REMARKS

The application has been reviewed in light of the Non-Final Office Action mailed October 29, 2004. At the time of the Non-Final Office Action, claims 1-26 were pending in this application, and all of these claims were rejected.

AMENDMENTS

FIGURE 2

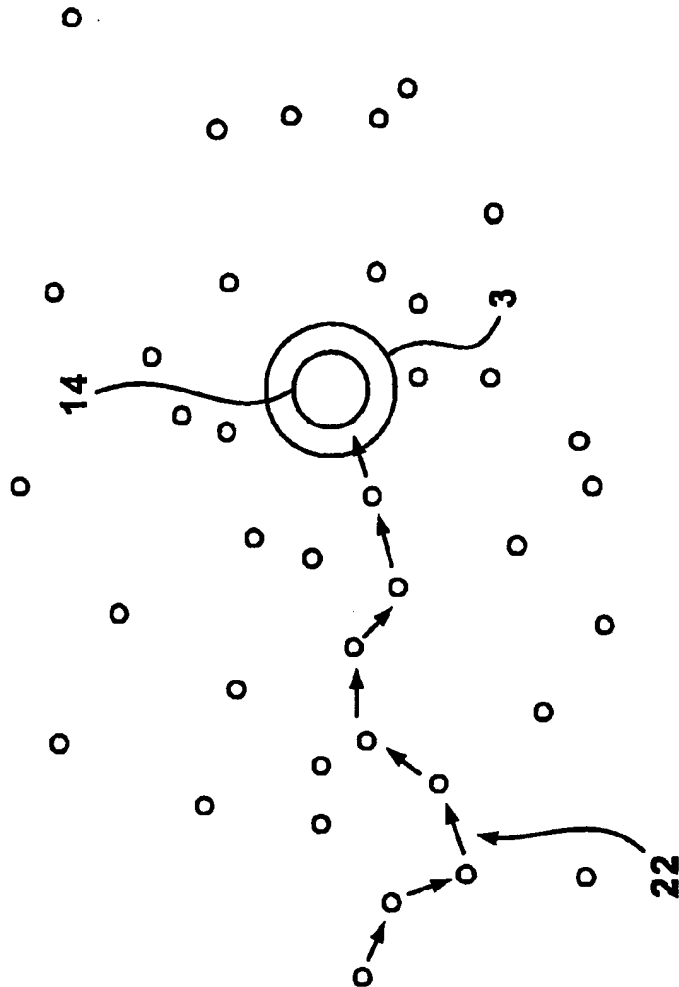
The Examiner objected to the drawings as not complying with 37 C.F.R. 1.83(a), 1.84(h)&(j) and MPEP 608.02(d) for not showing each and every claim element. The Applicants have amended the drawings and specification to overcome the Examiner's objection.

Please replace Figures 1 and 2 with replacement Figures 1-2 and please add new Figures 3-4, which are attached as Exhibit 1 hereto. (A marked-up copy of the drawings is being provided for the convenience of the Examiner and is attached as Exhibit 2 hereto).
